Application Number: 10/827,285
Filing Date: April 20, 2004
Appellant(s): CHEN ET AL.

EXAMINER'S ANSWER

Claims 1-4, 6-10 and 12 are rejected under 35 U.S.C. 102(b) as being anticipated by Nagai et al. (U.S. Patent 4,647,271).

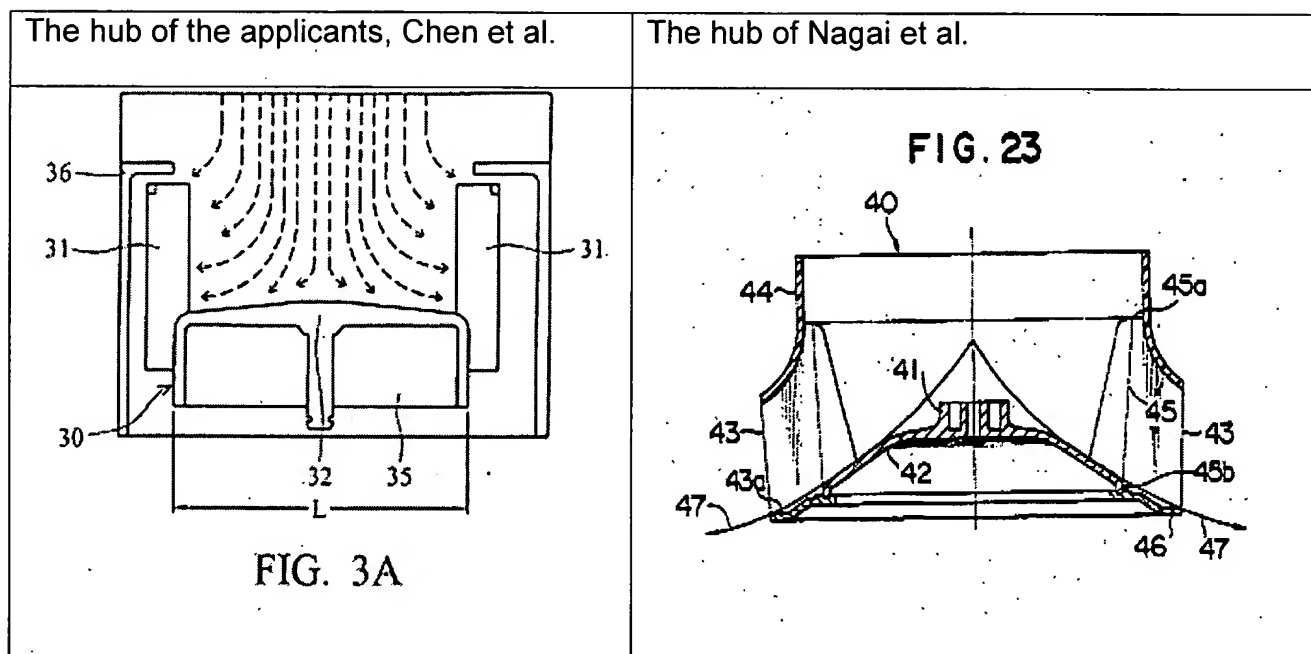
Appellants apparently have relied on the difference in nomenclature between elements in the invention and the same corresponding elements in Nagai et al. to argue the rejection under 35 USC 102. Appellants misrepresent the hub plate (figure 23,

element 42, see below) to be a different part than hub (41). Both element numbers (41 and 42) describe different areas of one integral part formed at the same time (col. 9 lines 18-21). The argument that the blades of Nagai et al. are not directly arranged on a hub is not persuasive since both hub (41) and hub plate (42) are the structural equivalent to the applicant's hub (applicants' drawing figure 3, element 32, see below). Also, the claim does not make any mentions that the hub should not interfere with the airflow.
